febi 28798, 30167, 40717

Fiat Ducato II, III; Iveco Daily III, IV, V and VI

Engine: 2.3-litre JTD F1AE

Air Conditioning Compressor Auxiliary Drive Belt

Fig 1 - Auxiliary drive diagram (up to and including engine No. 0113089), fitted with tensioner pulley 30167 and multi V-ribbed belt 28798.

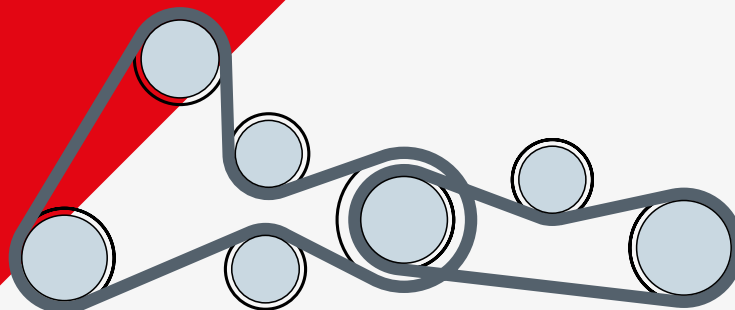
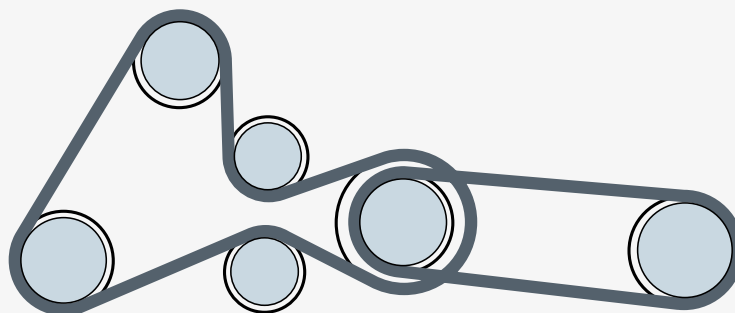
During the production period, Fiat and Iveco updated the layout routing and size of the auxiliary drive belt for the air conditioning compressor. This is applicable on several models fitted with the 2.3-litre JTD engine, starting from engine No. 0113090.

The update completely removed the requirement for the tensioner pulley used with the conventional 987 mm multi V-ribbed belt, fitted up to and including engine No. 0113089. (Fig1)

This was replaced with a shorter 903 mm elastic multi V-ribbed belt, which is routed as per the diagram above. (Fig2)

Note: for vehicles fitted with engines up to and including engine No. 0113089, this can also be retrofitted with the elastic multi V-ribbed belt 40717 during routine maintenance. This eliminates the requirement for the tensioner pulley altogether.
